MIPS R4000PC/SC Errata, Processor Revision 2.2 and 3.0

May 10, 1994

Figure 1a: Power-on Reset or Cold Reset - Workaround for Bug# 54

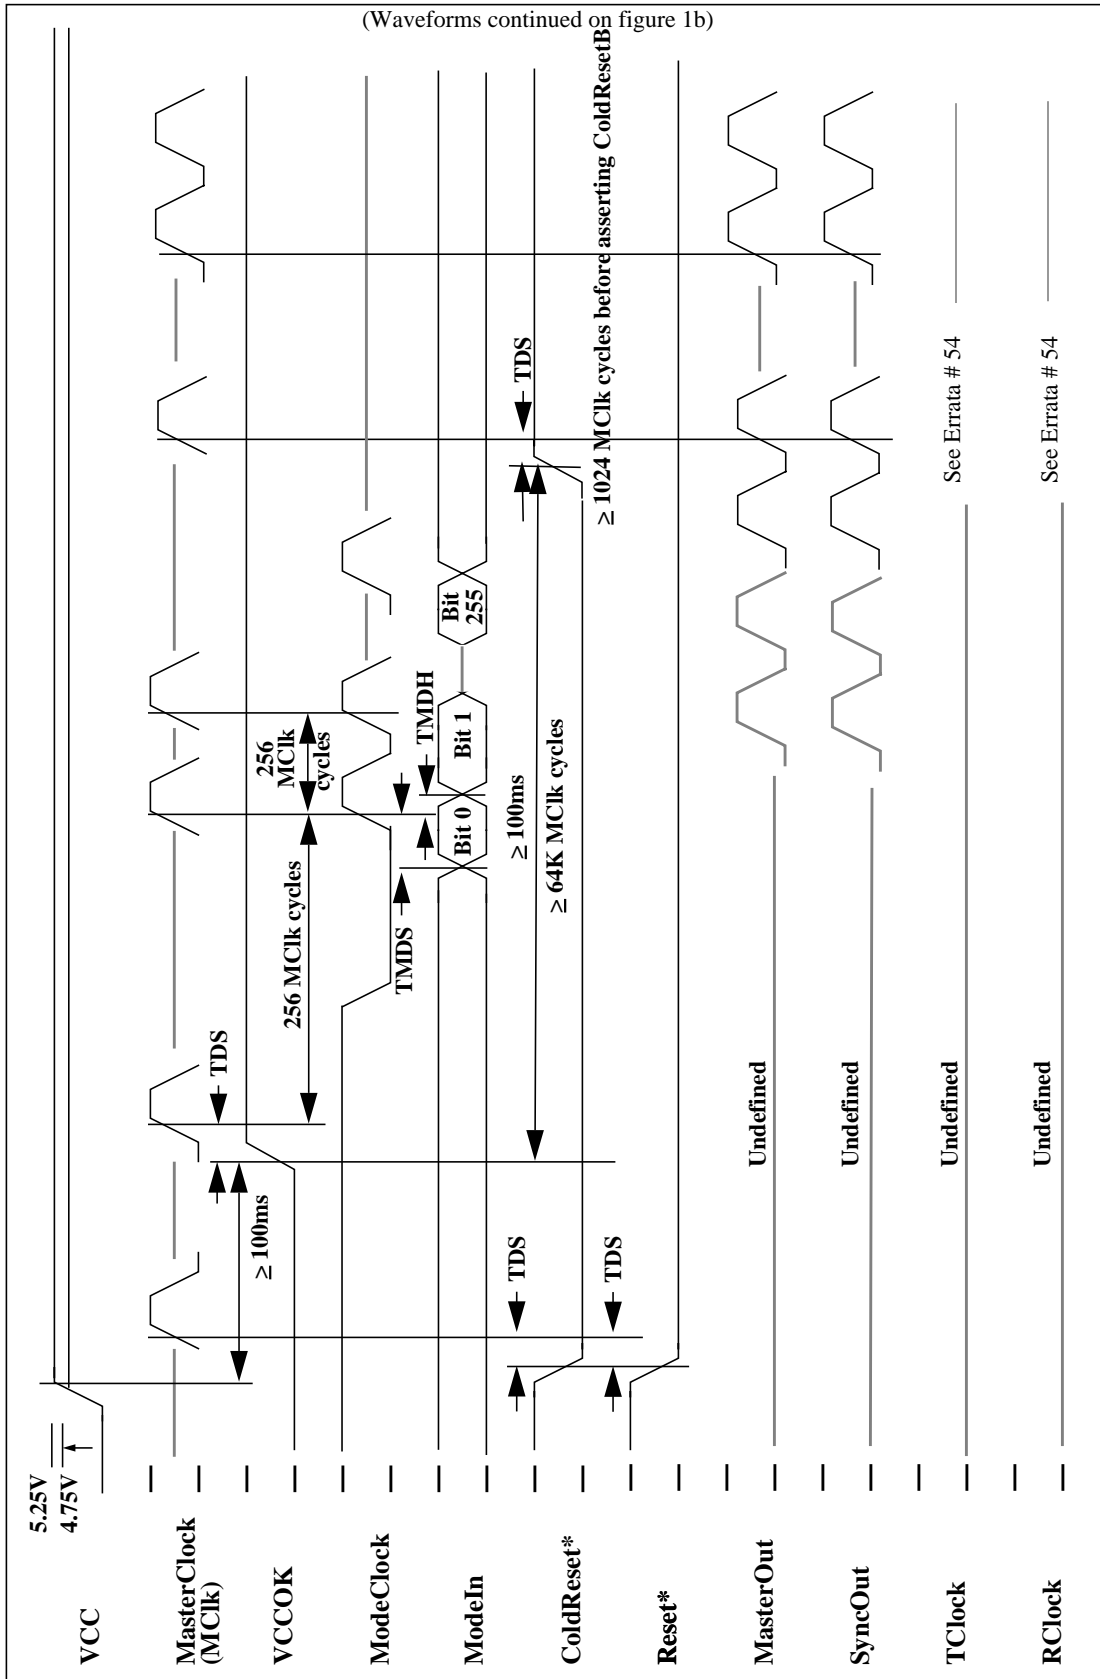
- 54.** R4000PC, R4000SC: During the power up sequence, the period of TClk and RClk may not be as expected for at least 1024 MasterClock cycles following the de-assertion of ColdResetB. The above bug is true for all system interface divisors. Furthermore, if the system interface divisor other than 2 (i.e. 3,4,6 & 8) is used, TClk and RClk's rising edge may not align to the rising edge of the MasterClock, as specified.

Thus, for system with interface divisor set to two, the only violation will be that the TClk and RClk's period might not be valid within 64 MasterClock after the ColdResetB is de-asserted.

Workaround: Assert a second ColdResetB after at least 1024 MasterClock cycles from the de-assertion of the first ColdResetB. ResetB should remain asserted until at least 64 MasterClock cycles following the de-assertion of the second ColdResetB. TClk and RClk will then be valid 64 MasterClock cycles after the de-assertion of the second ColdResetB and their edge alignment with respect to MasterClock will be as specified. Figure 1a & 1b show the waveforms in more detail. Note that the waveforms in Figure 1b are continuation of the those in figure 1a.
